产品变更需求通知单  
Product Spec Change Notice

PCN编号: PCN NO.:	PCN-C1586S_REV_A		
产品名称: Part Description	AT,4 POS, PLUG	安费诺料号: Amphenol P/N:	AT06-4S ALL MODIFICATION (See Appendix)
订单号: P/O:	N/A	数量: Quantity:	N/A
变更性质: Change Property:	<input type="radio"/> 临时性 Temporary <input checked="" type="radio"/> 永久性 Permanent	有效期限: Effective Period:	N/A
变更项目: Change Item:	<input type="checkbox"/> 材质 Material <input checked="" type="checkbox"/> 尺寸 Size <input type="checkbox"/> 工艺 Process <input checked="" type="checkbox"/> 外观 Appearance <input type="checkbox"/> 表面处理 Surface treating <input type="checkbox"/> 性能 Performance <input type="checkbox"/> 其它 Others

AT06-4S-XXX		AT06-4S-XXX	
	Old		New

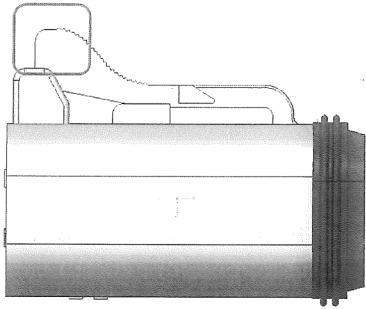
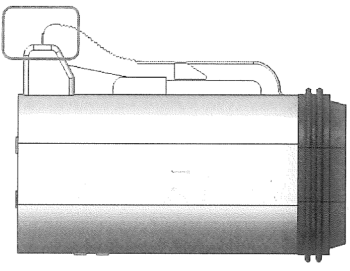
In effort to continuously improve our products, We reduce the height on the latch of AT series 4 pos plug for better pressing sensation.  
(为了持续改进产品, 我们将降低AT系列4 POS 插头按键位置高度以获得更好的按压手感)

This is a continual change so the current and previous revisions of this part can be used interchangeably in the field. This change is being phased in gradually and previous revisions may remain stocked until use.
